PUBLIC INTEREST REVIEW FOR GROUNDWATER APPLICATIONS

TO: Water Rights Section Date 06/14/2016
 FROM: Groundwater Section Phillip I. Marcy
 SUBJECT: Application G- 18301 Reviewer's Name
 Supersedes review of _____ Date of Review(s) _____

A. GENERAL INFORMATION: Applicant's Name: Bob Harrell County: Baker

A1. Applicant(s) seek(s) 6.5 cfs from 3 well(s) in the Powder Basin,
Baldock Slough subbasin

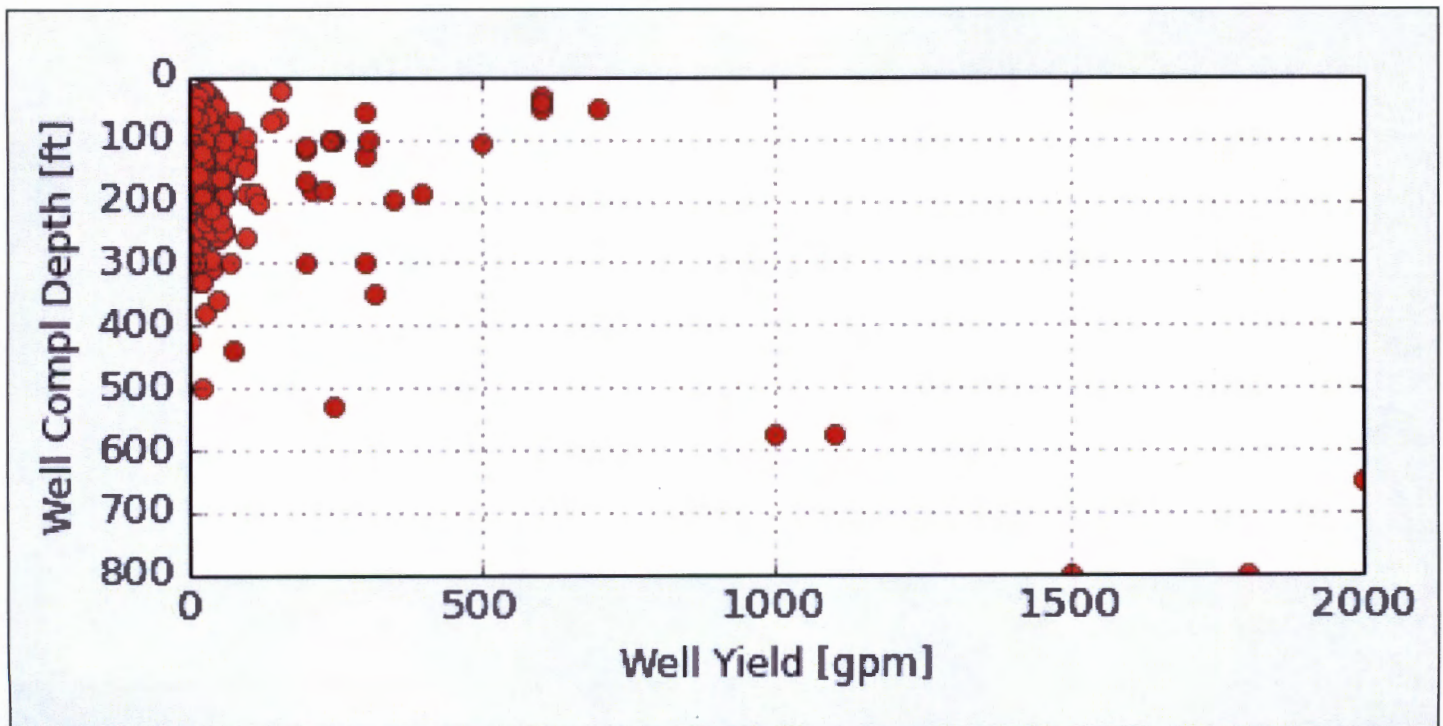
B3. **Groundwater availability remarks:** Wells producing 1000 or more GPM are infrequent in this area, and all are constructed to produce from fractured bedrock at considerable depth (greater than 500 feet, see Figure 2). The proposed POA locations are in close proximity to a ridge composed of Mesozoic intrusive and sedimentary rocks. These older rocks generally yield little groundwater, and well logs near the proposed POA locations report yields of less than 5 GPM from these units. Fractured volcanic units utilized by high yield wells to the west may not be present at the proposed locations, or may be present much closer to land surface where groundwater may not be present in any significant volume. Wells completed into these basalts within 100 feet of the land surface typically yield less than 50 GPM.

Figure 2: Statistics from well log reports in the vicinity of the proposed POA wells indicate that few wells obtain yields similar to those expected by the applicant (~1000 GPM). The few wells reporting 1000 GPM or greater are more than 500 feet deep, producing from fractured basalt flows buried much deeper than they are expected at the proposed POA locations.

Special Condition: Proposed POA wells shall not be constructed in a manner that allows production from shallow alluvium above volcanic rock, or from the fractured uppermost portions of the Powder River Volcanics. Wells penetrating the Powder River Volcanics must be continuously cased and continuously sealed to produce only from beneath no less than 10 feet of dense, unfractured bedrock.
